## **MUIR WOODS SUBDIVISION, FIRST UNIT, RE-SUBDIVISION AND ADDITION TO LOT 10**

Engineering Comments: FINAL PLAT COMMENTS (should be addressed prior to submitting the FINAL PLAT for review and/or signature by the City Engineer):

APPLICATION NUMBER 2 DATE September 21, 2017  
 APPLICANT Muir Woods Subdivision, First Unit, Resubdivision and Addition to Lot 10  
 REQUEST Subdivision

# DETAIL SITE PLAN

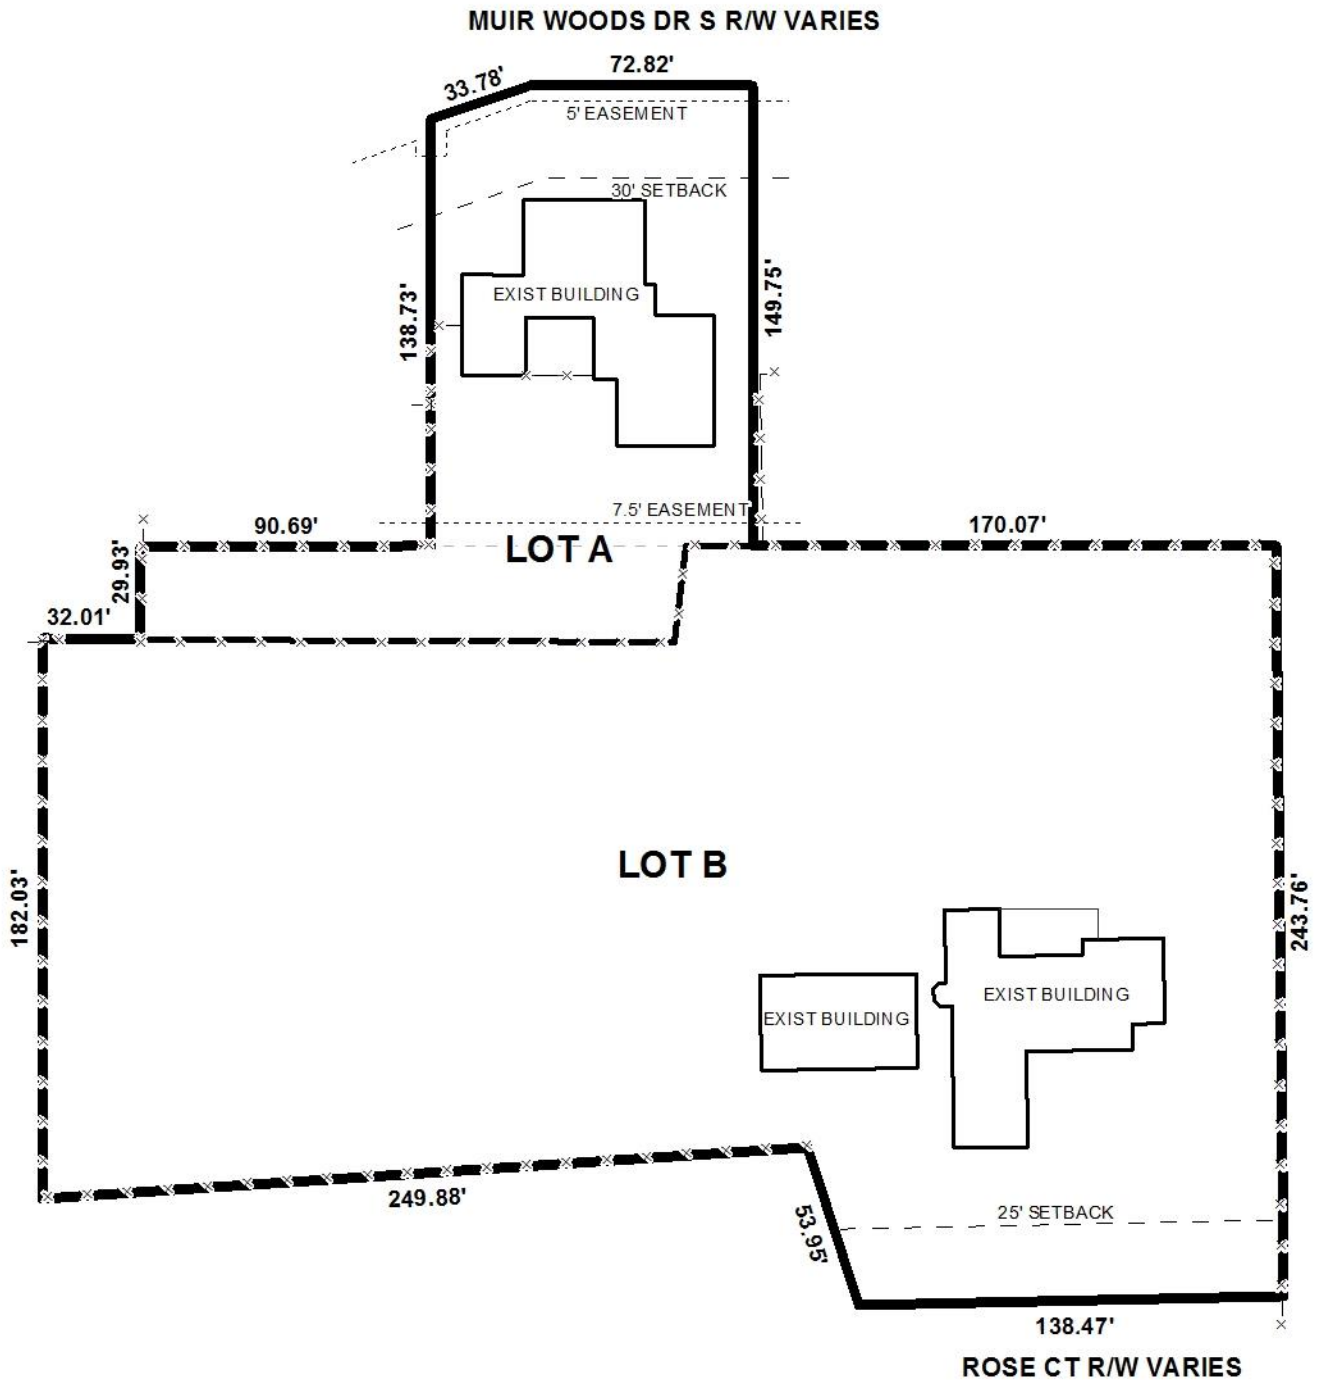
Lot A has frontage on Muir Woods Drive South, a minor street with curb and gutter requiring a 50' right-of-way width. Lot B has frontage on Rose Court, an unpaved minor street without curb and gutter requiring a 60' right-of-way width. The plat illustrates sufficient right-of-way along Muir Woods Drive South, but not along Rose Court; however, dedication was not previously required in 2006 or 2012 and, as such, it should also not be required for the request at hand.

Both lots are irregularly shaped, but nevertheless meet the minimum size requirements of the Subdivision Regulations for lots served by public water and sanitary sewer. Their sizes are appropriately labeled in square feet and acres on the preliminary plat and, if approved, should be retained on the Final Plat; or, provision of a table providing the same information should suffice.

The required 25' minimum building setback line is illustrated along Lot B, and a 30' minimum building setback line is illustrated along Lot A; both of which should be retained on the Final Plat, if approved.

A 5' utility easement and 7.5' drainage and utility easement are illustrated along the front and rear portions of Lot A, respectively. As such, if approved, a note should be required on the Final Plat stating no structures shall be built in any easement.

- 1) Revision of the plat to illustrate a sufficient 60' right-of-way width along Rose Court;
- 2) placement of a note on the Final Plat stating there shall be no future subdivision of Lot B until Rose Court is improved to City Engineering standards;

- 3) placement of a note on the Final Plat stating that the lots are limited to their existing curb cuts, with any changes in their sizes, locations or designs to be approved by Traffic Engineering and conform to AASHTO standards;

- 4) retention of the lot sizes in both square feet and acres on the Final Plat, or provision of a table providing the same information;
- 5) retention of the minimum building setback lines along both street frontages;

- 6) placement of a note on the Final Plat stating no structures shall be erected in any easement;
- 7) compliance with Engineering comments: (FINAL PLAT COMMENTS (should be addressed prior to submitting the FINAL PLAT for review and/or signature by the City Engineer): A) Provide all of the required information on the SUBDIVISION PLAT (i.e. signature blocks, signatures, certification statements, written legal description, required notes, legend, scale, bearings and distances) that is required by the current Alabama State Board of Licensure for Professional Engineers and Land Surveyors. B) Add a note to the plat stating that all easements shall remain in effect until vacated through the proper process. C) Show and label each and every Right-Of-Way and easement. D) Provide and label the monument set or found at each subdivision corner. E) Add a signature block for the Owner, Notary Public, Planning Commission, Traffic Engineer, and City Engineer. F) Provide the Surveyor's Certificate and Signature. G) Provide the Surveyor's, Owner's (notarized), Planning Commission, and Traffic Engineering signatures. H) Add a note to the SUBDIVISION PLAT stating that a Land Disturbance permit will be required for any land disturbing activity in accordance with Mobile City Code, Chapter 17, Storm Water Management and Flood Control); the City of Mobile, Alabama Flood Plain Management Plan (1984); and, the Rules For Erosion and Sedimentation Control and Storm Water Runoff Control. I) Add a note to the Plat stating that the approval of all applicable federal, state, and local agencies (including all storm water runoff, wetland and floodplain requirements) will be required prior to the issuance of a Land Disturbance permit. J) Add a note that sidewalk is required to be constructed, and/or repaired, along the frontage of each lot, or parcel, at time of new development or construction, unless a sidewalk waiver is approved. K) Provide a copy of the FINAL SUBDIVISION PLAT to the Engineering Dept. for review. No signatures are required on this drawing. L) After addressing all of the FINAL SUBDIVISION PLAT review comments by the Engineering Dept. provide the ORIGINAL (with all other signatures)
